Planning Officer's Report – LDCA AUGUST 2021

APPLICATION	2021/52 – Construction of a 3 Bedroom Split Level Dwelling
PERMISSION SOUGHT	Permission in Full
REGISTERED	29 th June 2021
APPLICANT	Theo & Sone Meij
PARCEL	SCOT0638 & SCOT0649
SIZE	0.23 & 0.15 acres (954 & 634m ²)
LOCALITY	Upper Cleughs Plain (Scotland Registration Section)
ZONE	Intermediate
CONSERVATION AREA	None
CURRENT USE	Vacant Crown Land
PUBLICITY	The application was advertised as follows: <ul style="list-style-type: none">▪ Sentinel Newspaper on 1st July 2021▪ A site notice displayed in accordance with Regulations.
EXPIRY	15 th July 2021
REPRESENTATIONS	One received from neighbour
DECISION ROUTE	Delegated / LDCA / EXCO

Diagram 2: Site Plan (Superseded)

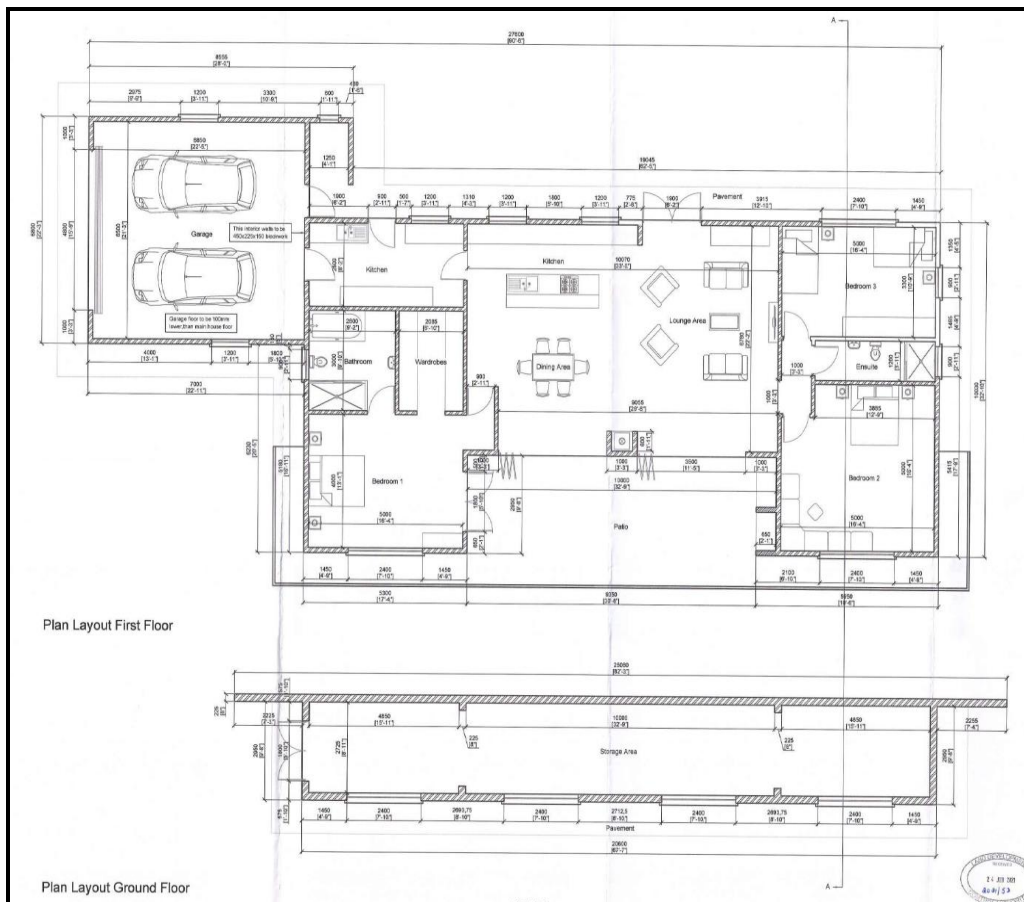
The site sits at the end of an access track through the forest from the road junction near Scotland offices. Upon reviewing the plans submitted in the original application, the planning officer advised the applicant that both the proposed building design layout and proposed access did not make best use of the land, but created unnecessary excavated scaring and unnecessary land spill to support. It was suggested to the applicant to invert the house layout, which would allow access directly onto the site from the existing track following the natural contour of the land. This would provide access directly into the proposed double garage. (See diagrams 2 & 3: original plans).

The plans were revised to conform to the suggestions made by the Planning Office. (see diagrams 4 & 8: revised plans)

Diagram 4: Site Plan (Revised)

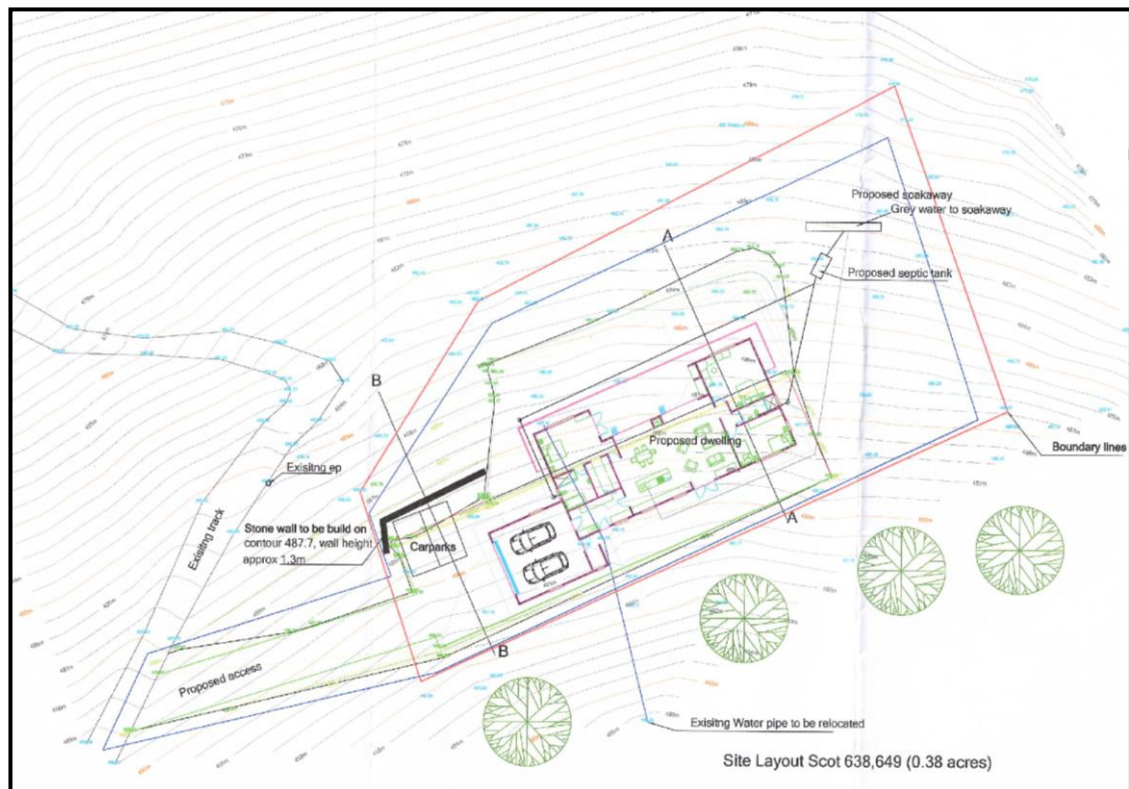
The position of the proposed septic tank and soakaway on the north east corner of the development boundary will not affect the neighbouring property.

Diagram 5: Site Cross Section A-A

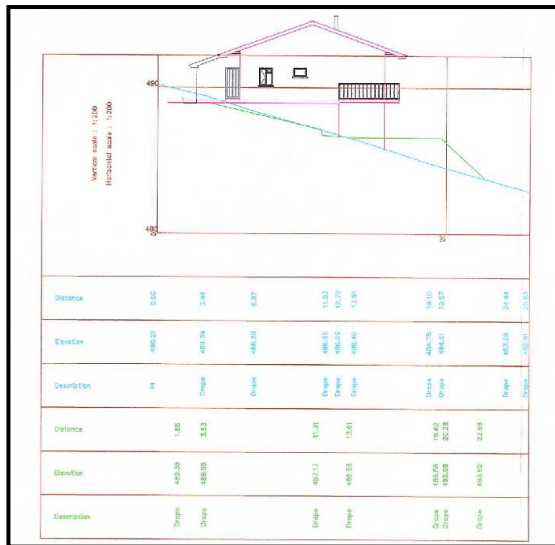
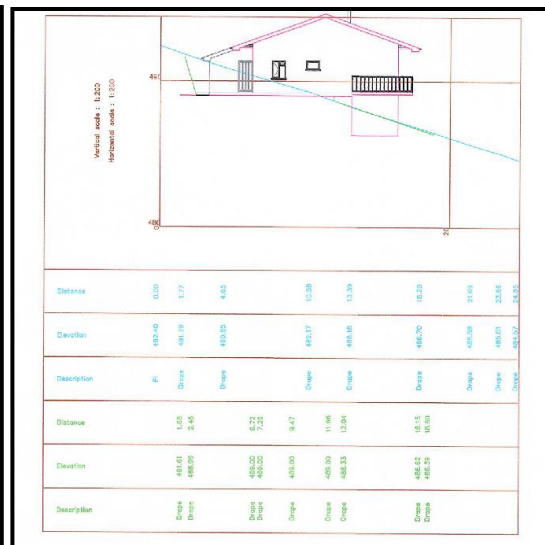
Traditional site excavation is proposed on the section of land that is naturally sloped at approximately 20 degrees. The excavation will form a split level and create an embankment at the rear of the house measuring approximately 2900mm in height at its highest point, thus complying with the LDCP policy IZ 1. F) *“the design and layout do not generally entail excavation nor making up of levels to a depth or height in excess of 3m.”*

While excavation into the landscape is not encouraged, the embankment in this case as a result of the split level design does not exceed a height of 2.9 metres, thus complying with the LDCP policy IZ 1. F) *"the design and layout do not generally entail excavation nor making up of levels to a depth or height in excess of 3m."*
